AMENDMENTS TO THE DRAWINGS

REMARKS

Figure 2

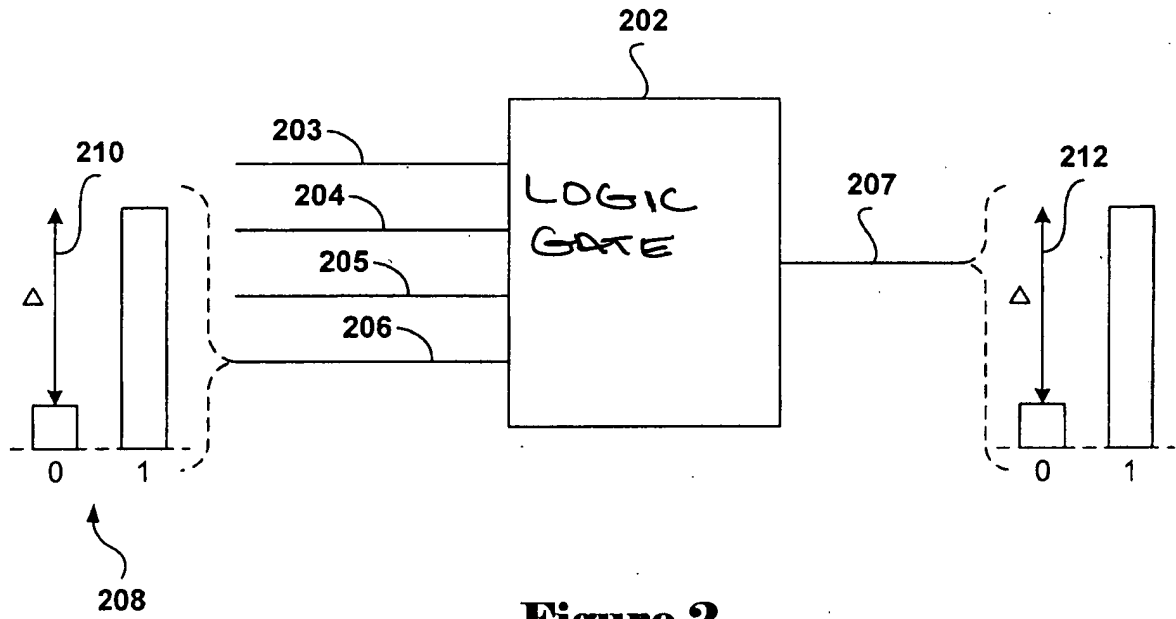
Figure 2 is presented with redline corrections. A new set of formal drawings is also submitted for approval.

Claims 1-20 are pending in the current application. In an Office Action dated December 7, 2005 ("Office Action"), the Examiner objected to Figure 2, objected to claims 1, 3, 5, 7, 9, 12, 14, 16, 18, and 20, and indicated that claims 1-20 would be allowable once the objections have been addressed. Applicants' representative would like to thank the Examiner for the conditional allowance of claims 1-20. Applicants' representative has addressed the objection to Figure 2 in the above amendments to the drawings, and has addressed certain of the claim objections in the above amendments.
